Reference: Beaver Valley Power Station, Unit No. 1 and No. 2  
BV-1 Docket No. 50-334, License No. DPR-66  
BV-2 Docket No. 50-412, License No. NPF-73  
Response to Safety Evaluation Report for Station Blackout  
(TAC Nos. 68510 and 68511)

BVPS Station Blackout Safety Evaluation Report  
Responses

FIGURE 1 - BVPS  
Unit 1 and 2 AAC Cross-tie

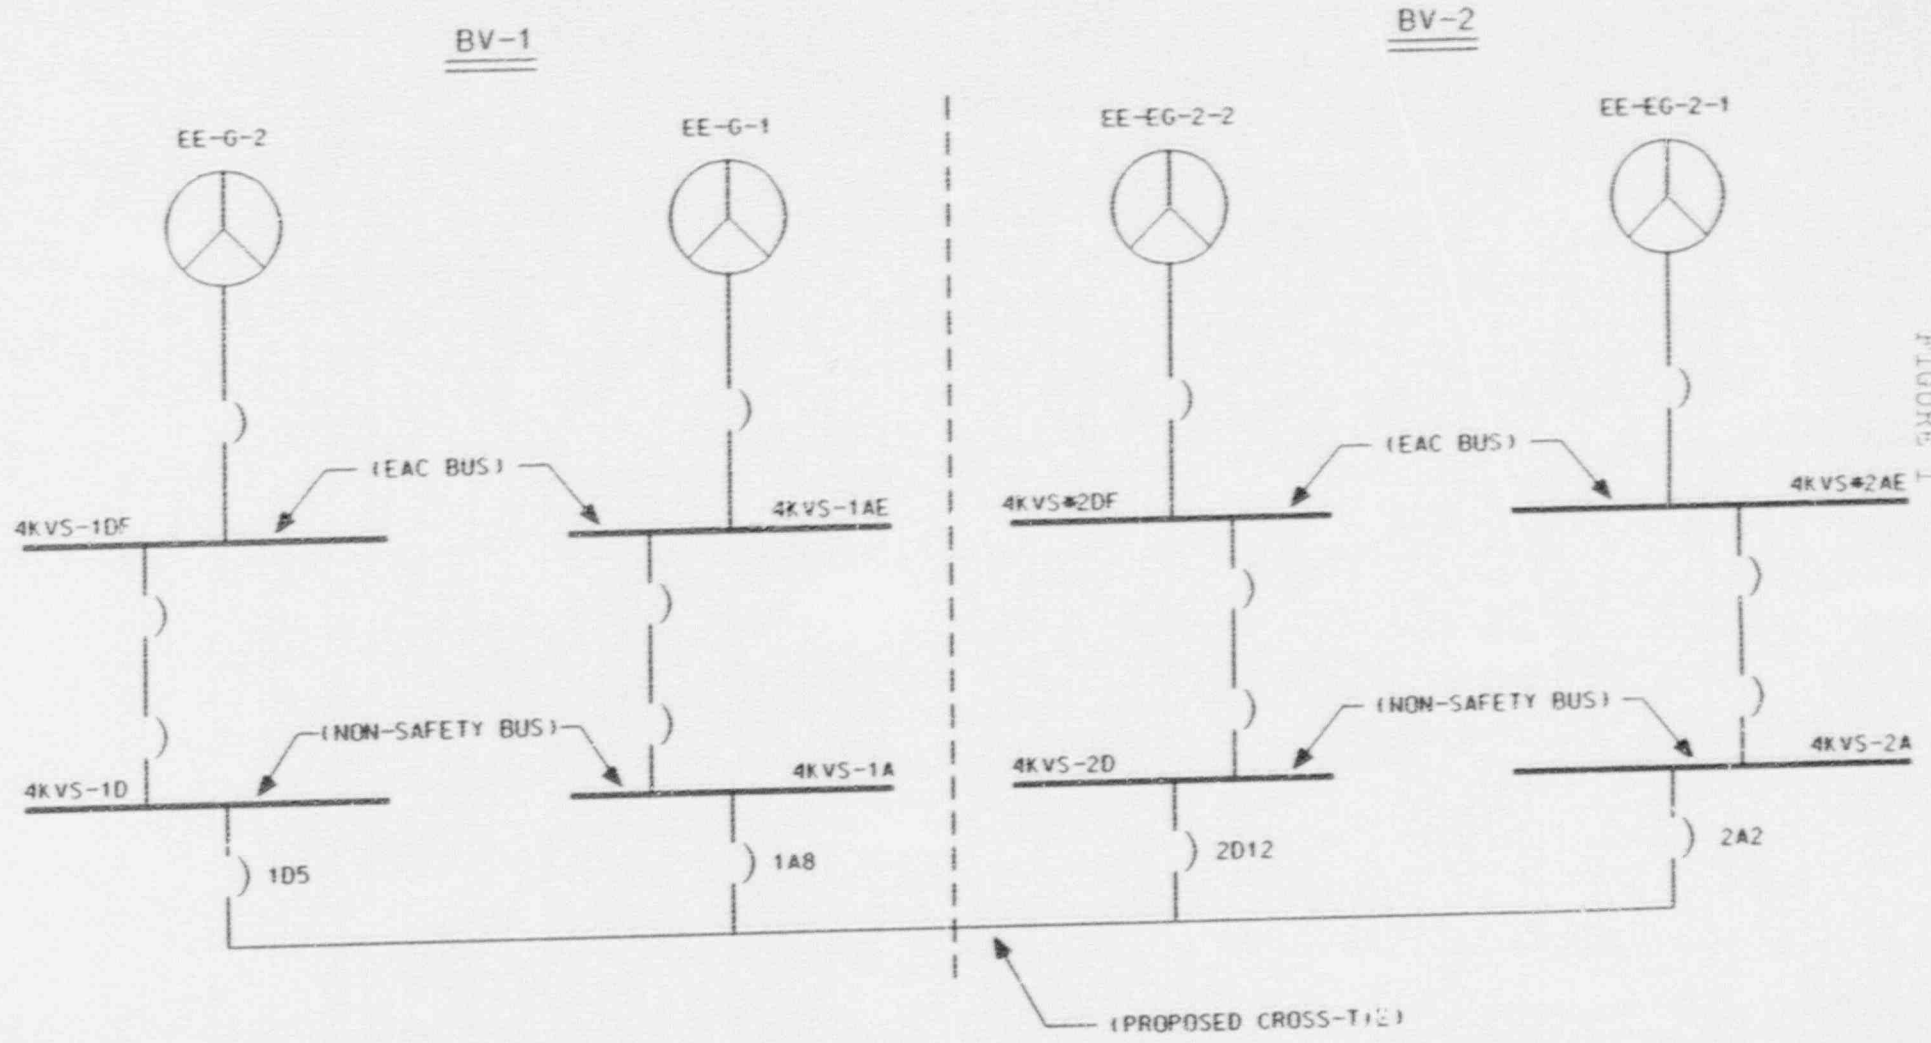
DLC should provide a full description including the nature and objectives of the required modifications identified above in the documentation supporting the station blackout submittals that is to be maintained by DLC.

Figure 1 is a diagram depicting the electrical cross-tie for Beaver Valley Power Station Units 1 & 2. The diagram identifies the new breakers to be added to existing switchgear and the new cubicle and breaker necessary for 4KVS-2D. Preliminary design work listing protection and relaying options has been developed by the Controls Engineering Department of DLC.

The cross-tie is to be implemented by tying the normal 4KV busses within each unit. The normal bus of one unit will then be cross-tied to the normal bus of the second unit. Control switches will be installed in the emergency switchgear rooms and in the normal switchgear rooms. The control switches will align the protection and control circuits to allow any of four diesel generators to power either bus within the blacked out unit. The addition of these control switches will allow greater operator ease in aligning the unit rather than performing individual breaker operations.
